ISLAND AVE., PEAKS ISLAND.

94-R-8

APPLICATION FOR PERMIT

AP Island Avenue, Peaks Island (84-R-32)

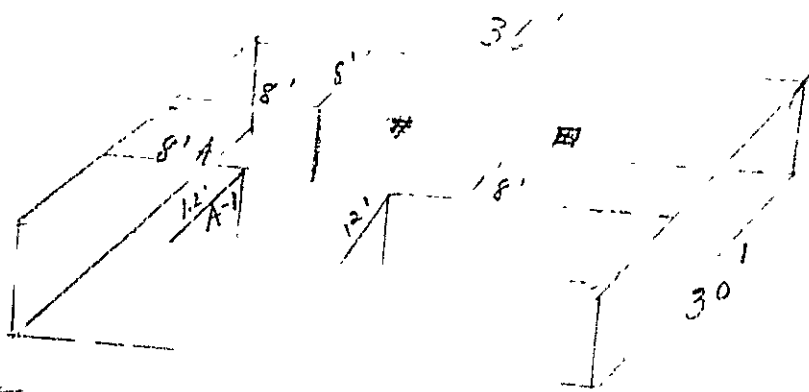
Examination of your sketch showing location of partitions to be removed in store at the above location and study of roof framing found in our files in connection with work done on the building about two years ago indicate that the partition about 12 feet long and marked A-1 on your sketch, is located directly over a girder supporting first floor framing and in turn supports the roof timbers over this area of the building. This being the case, if the partition is to be removed, a beam of considerable size will need to be provided to take its place, and perhaps one or more columns will need to be provided beneath girder in first floor framing depending upon where the column supporting beam under roof lands in relation to those supporting girder. Under these circumstances we are unable to issue a permit for the proposed alterations until information has been furnished to indicate that construction meeting Building Code requirements is to be provided.

Partitions marked A and A1 are the items in question for removal. Marked in ink are two post supporting two trusses for roof support. There is 33 in space from top of partition to roof rafters.

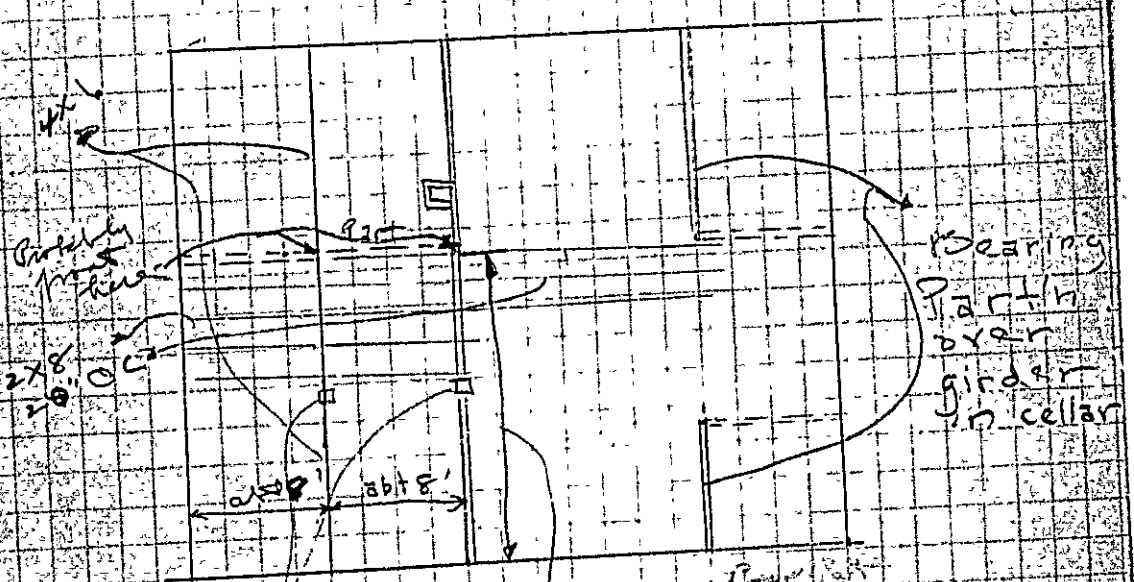
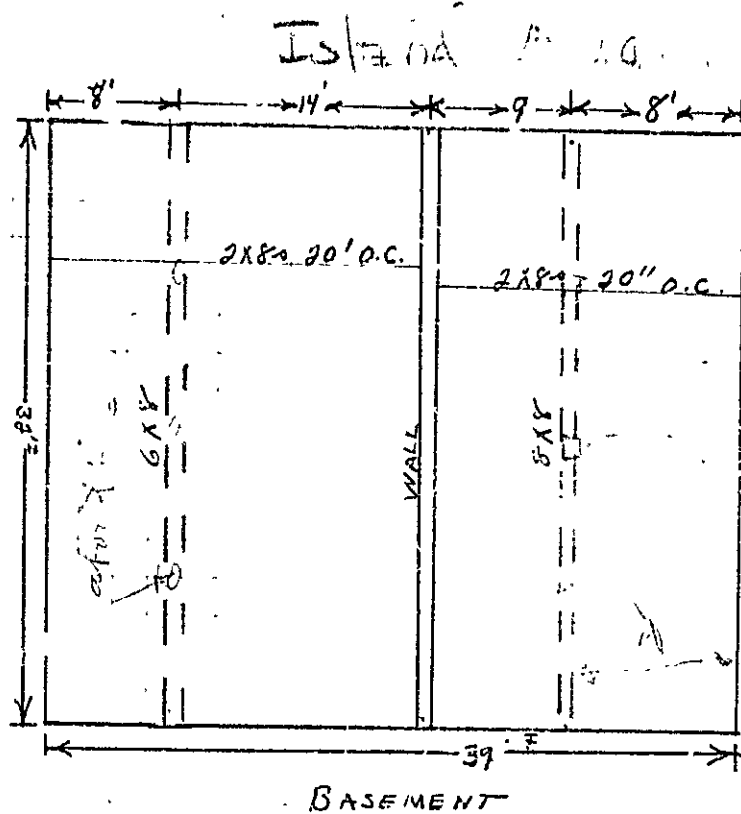
There are two 4x6 beams running under the 2x8 roof joists and extending from the Island Ave. front back toward the harbor. One of these is about eight feet from the exterior wall toward Greenwood Garden and the other one is about eight feet from that. This latter beam has some truss action but not a great deal but perhaps the strength of two 4x6s, one above the other, can be counted instead of just one.

This trussed roof is really in distress and sags quite badly, and the one toward Greenwood Garden is down a little.

A 6x6 post is to be provided approximately under the center of each of these structural members to extend from the top of the girder in the cellar (in the case of the one toward Greenwood Garden) up through the new ceiling to a form bearing under the 4x6. The other 6x6 post is to extend from a good bearing on the foundation wall which runs through about the center of the building up to the under side of the 4x6 which is at the bottom of the trussed arrangement.

While these measures will not bring the strength of the roof up to what it ought to be and would have to be if being constructed now, it is my belief that there will no longer be any hazard even if there should be a heavy snow load on the roof.

FLOOR PLAN

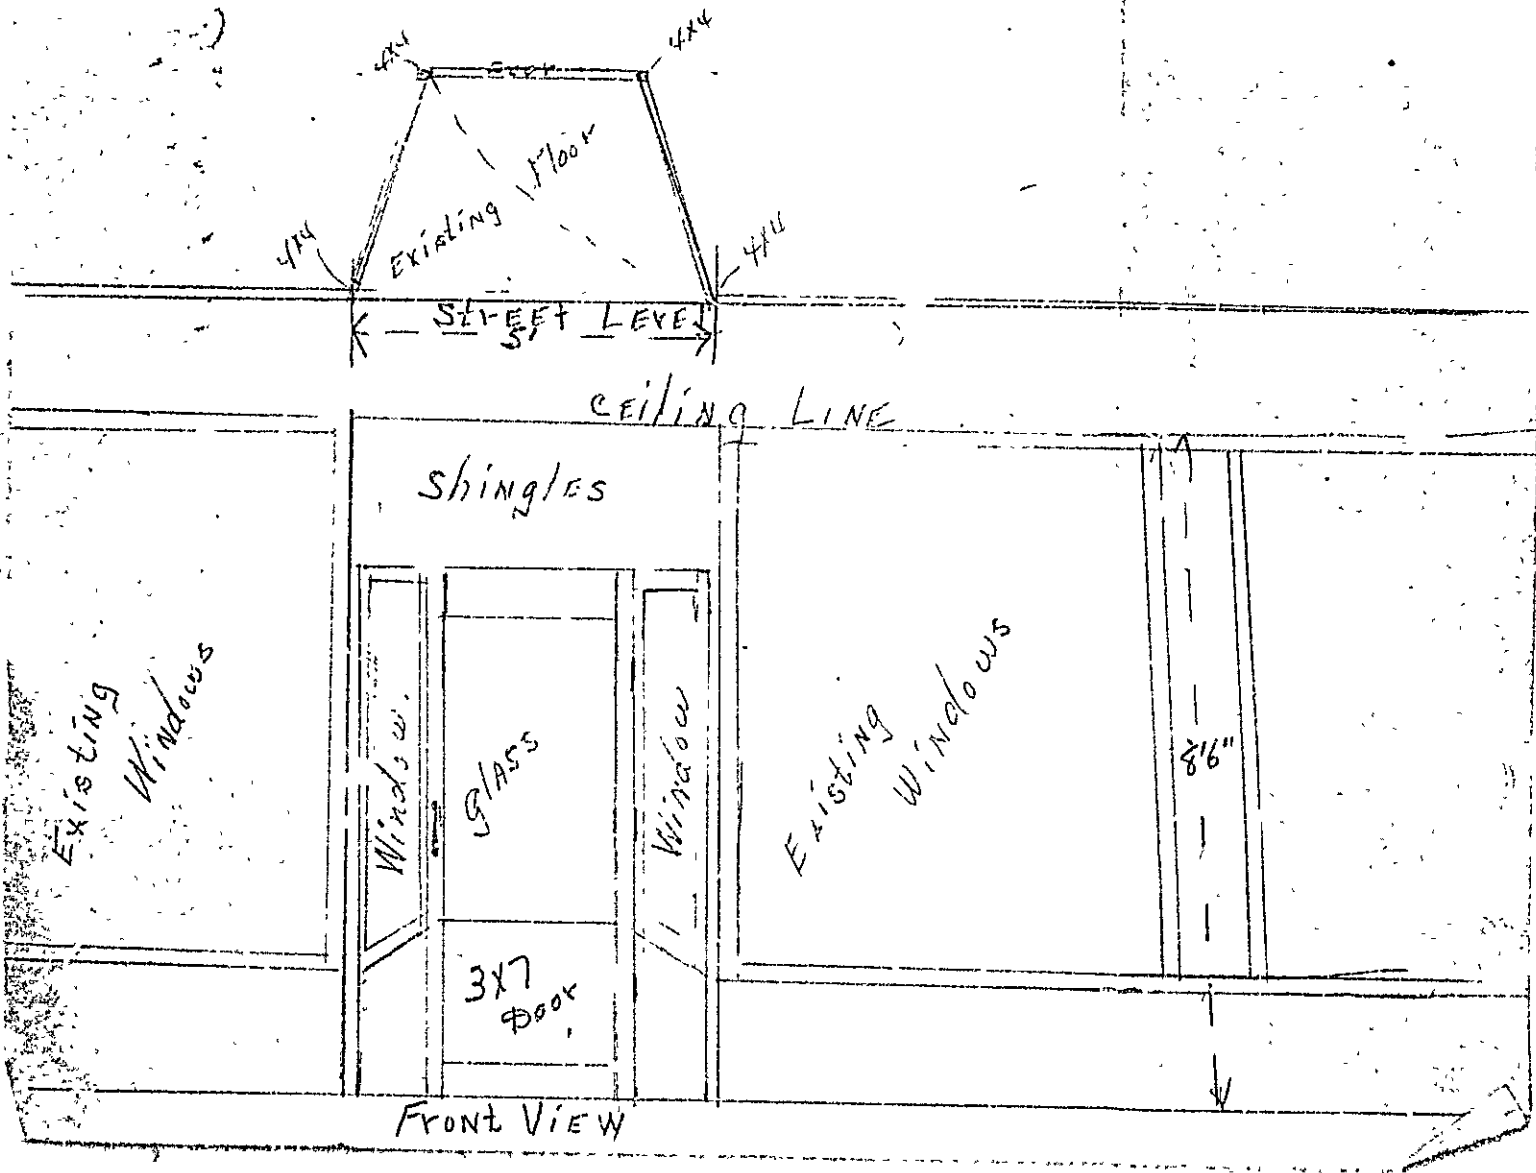
The girders are well supported, posts every 4.5 feet.

Sketch Side Wall Framing
Vertical Boarding

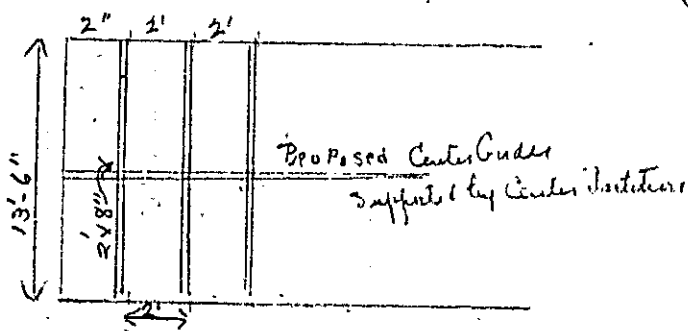
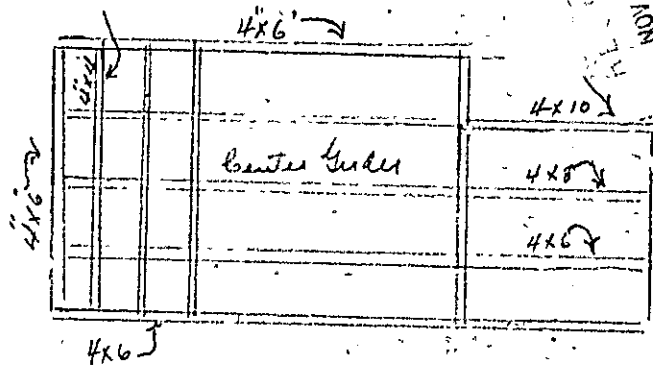
Instead of making a plan to show the framing of the floor and sills, the supports beneath the first floor and the wall and roof framing, Mr. Brackett has attempted to convey that information in his letter; but the written information is not adequate to establish compliance with the Building Code, as we are required to have shown, before a permit can be issued. This plan was requested in the seventh paragraph of my letter of November 5, and there is no way that I know of to get your permit issued without furnishing this plan and having it checked here; also the actual proposed arrangement of rooms and partitions and a designation as to which are new partitions and which are existing, also any partitions to be removed.

proposed to be changed to the dwelling, including full information about the present foundation, the size of sill and spans of sill, size, spacing and spans of floor joists and of rafters; the size, spacing and spans of the proposed ceiling joists and how they will be supported, together with the material to be used on the new ceilings; the material to be used on the new non-bearing partitions and existing material on that proposed on existing partitions and on the inside of exterior walls. Incidentally, your sketch should be changed to show which partitions exist, and which are proposed. There will also be question as to whether or not the present floor joists are strong enough to support the partitions, both those which exist and those which are proposed. In short, we need to know everything about this building which will allow us to check up its strength and fitness under Building Code requirements for use as a dwelling house. The only record as to its condition which we have been able to find is that in the Assessor's Record around 1924, which says that the building was then in poor condition. Perhaps it has been fixed up satisfactorily since, or you propose to do so now. If the latter, we should be told how you propose to fix it.

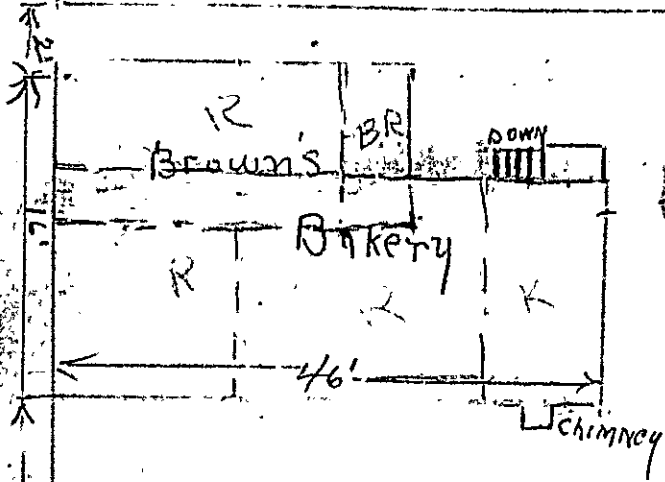
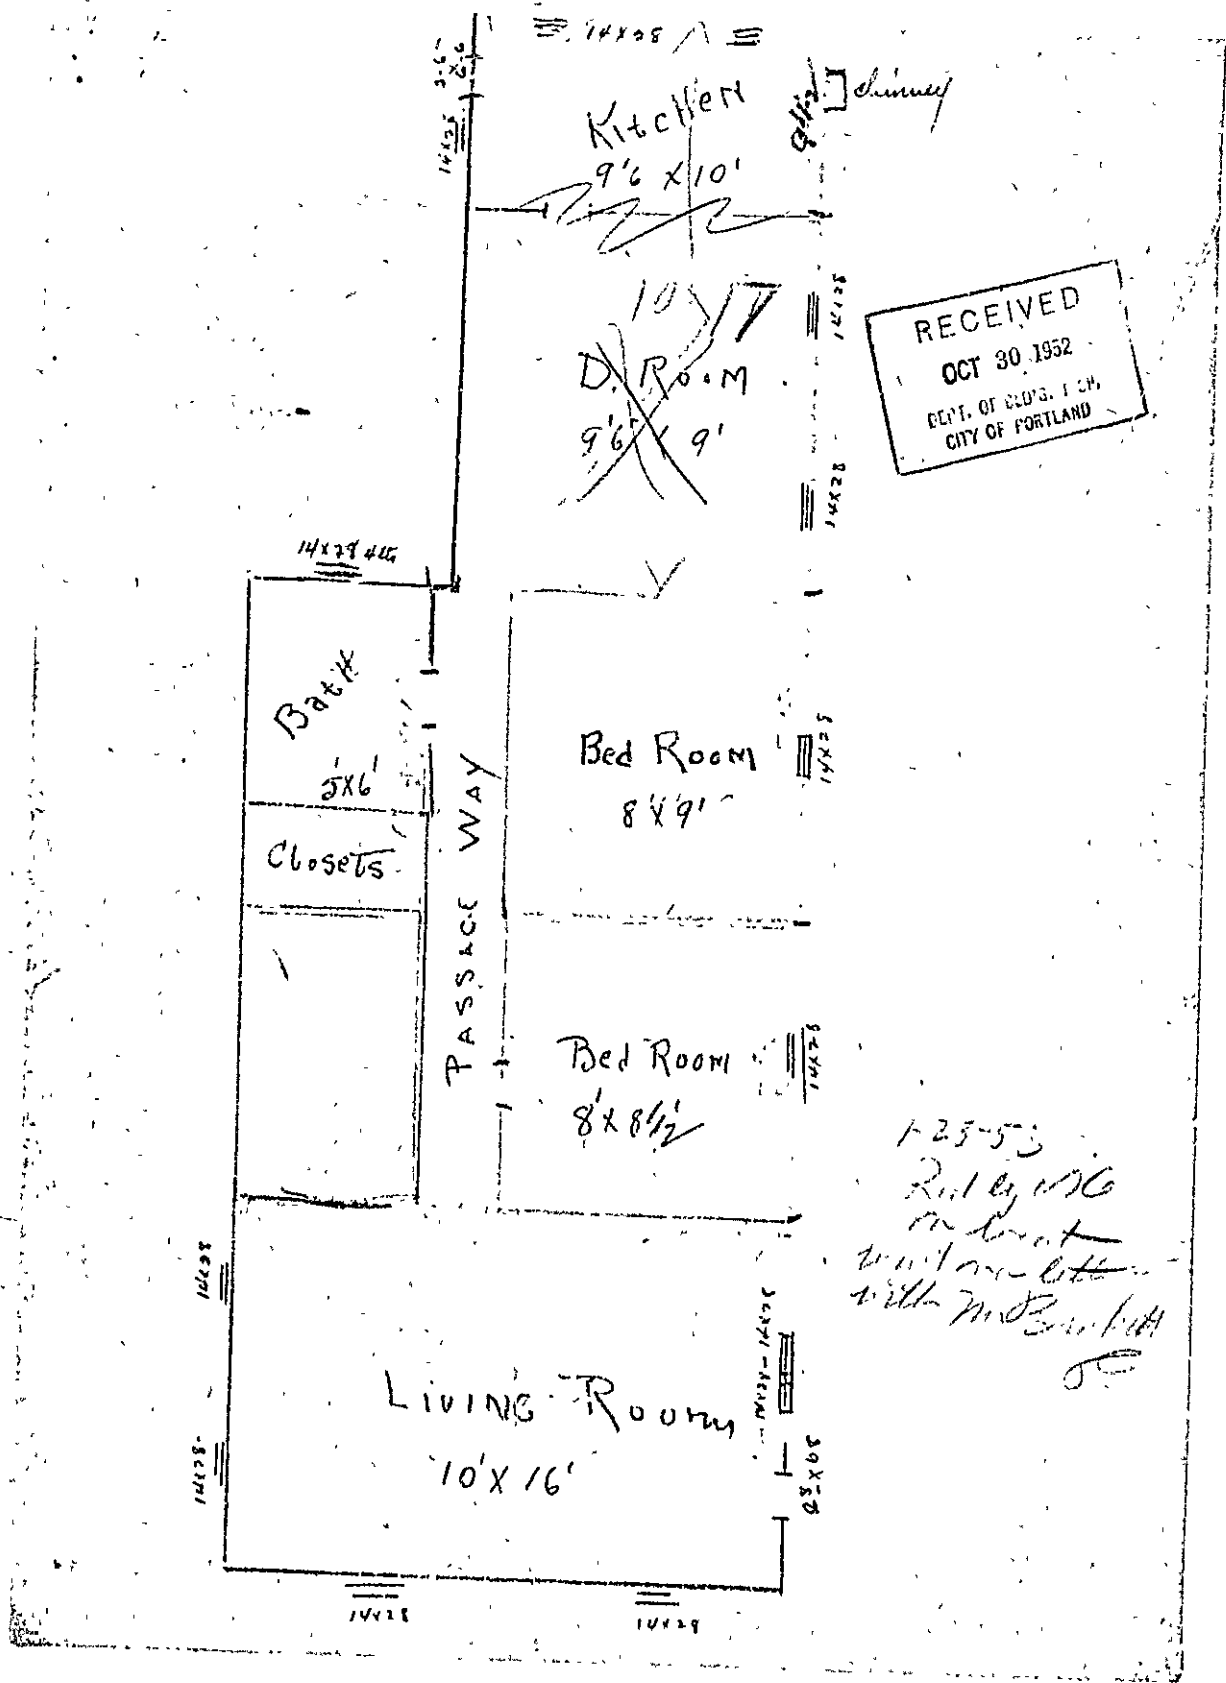
The Zoning Ordinance requires at least 10 feet between the proposed dwelling and the shooting gallery. The letter says that you mean to move the shooting gallery to give the required space between the two buildings. This will require a separate building permit, and with the application should be filed a plan giving full details of the proposed location of the building with its existing location, and the location of the proposed dwelling to the former; also the type of foundation proposed, size of sill and center girder, if any, spans and direction of span of floor joists and the spans for the rafters and proposed spacing of posts or piers if a continuous wall is not intended for foundation. This will all have to be worked out and the permit for moving the shooting gallery ready for issuance before we can issue the permit for change of use of the bakery.

The letter indicates some changes of windows and doors, but the sketch does not make clear what the present situation is and what is proposed, especially with regard to the doors. These changes should be shown and whether or not new porches and steps are to be provided outside of the doors. If so, a framing and foundation plan of each porch is needed.

It is necessary that you furnish a plan showing the outline and dimensions of the lot on which the building is, the location on the lot of the outline of the building, including any existing or proposed porches, outside chimneys and the like. Also to provide a plan to scale showing the first floor arrangement of the proposed building where existing partitions are and where new ones will be provided, and the location and over-all size between frames of all of the windows.
